Accessibility Survey

City of Downey Sidewiew Drive - Cedartree Road to Brookpark Road

Date of Inspection
6/15/2017

Disability Access Consultants

Curb Ramp : No Detectable Warnings

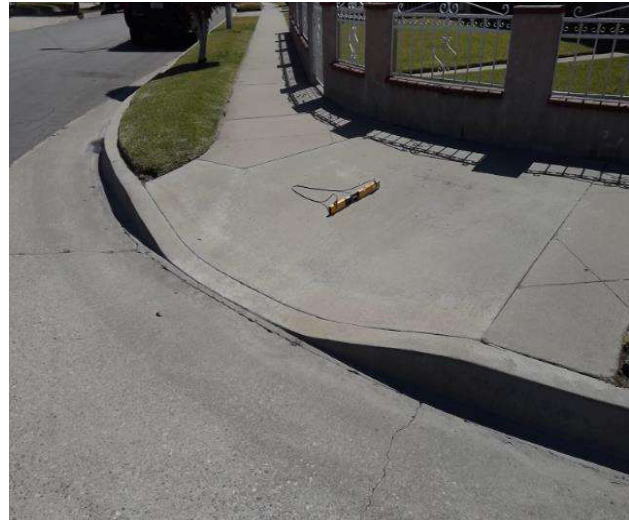
The curb ramp does not provide a detectable warning surface which includes truncated domes.

On-Site Finding Not Found

Provide compliant detectable warnings to surface.

Provide detectable warning to surface \$248

Code Reference CA 11B-406.5.12
